Van: [redacted]@shell.com
Aan: SodM [redacted]
Cc: SodM [redacted]
Onderwerp: Technische evaluatie Twente putten
Datum: dinsdag 22 december 2020 10:41:19

Report: EP202012203362

Nederlandse Aardolie Maatschappij**Second technical evaluation of Twente water injection wells TUB-7, TUB-10, ROW-7 and ROW-9**

Hierbij geef ik mijn reactie op uw bijgewerkte Seismisch risicobeheersplan Waterinjectie Twentevelden. De NAM heeft mij op 25 september 2020 ter afstemming het plan toegestuurd, zoals mijn brief van 9 juli 2020 verzocht (kenmerk 20171945 | INS-511). Deze nieuwe aanpassingen van het vigerende plan legde u mij voor om, na mijn reactie, uw definitief aangepast versie aan te kunnen bieden.

Figuur 2: Matrix behorend bij het seismische risicobeheerssysteem.

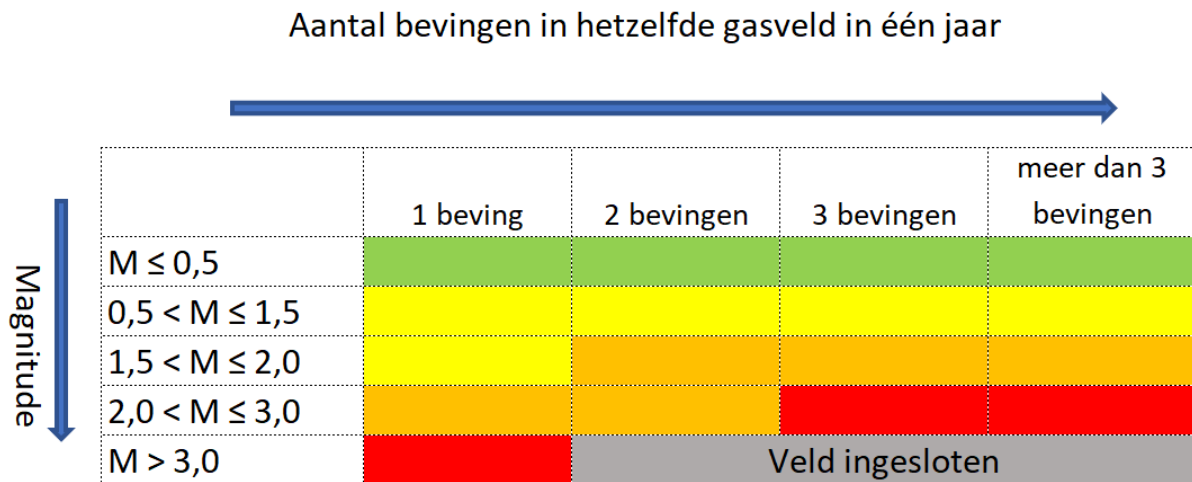
1. Ik vraag u om in het actieplan (Tabel 1) in de gele fase (na een beving tussen 0,5-2,0) als actie op te nemen dat met SodM als toezichthouder wordt overlegt over de duiding van de beving, aanpassing van het geologisch model en de aanbevelingen die u formuleert. Immers, u geeft aan dat voor de waterinjectie in Twentevelden '*geen bevingen worden verwacht*', gegeven dat geen bevingen zijn gemeten gedurende de gaswinning en eerste 9 jaar van waterinjectie. Een beving kan niet worden uitgesloten maar wijkt af van de historie van deze velden.

1. Ik vraag u om in het actieplan (Tabel 1) in de gele fase (na een beving tussen 0,5-2,0) als actie op te nemen dat met SodM als toezichthouder wordt overlegt over de duiding van de beving, aanpassing van het geologisch model en de aanbevelingen die u formuleert. Immers, u geeft aan dat voor de waterinjectie in Twentevelden *'geen bevingen worden verwacht'*, gegeven dat geen bevingen zijn gemeten gedurende de gaswinning en eerste 9 jaar van waterinjectie. Een beving kan niet worden uitgesloten maar wijkt af van de historie van deze velden.
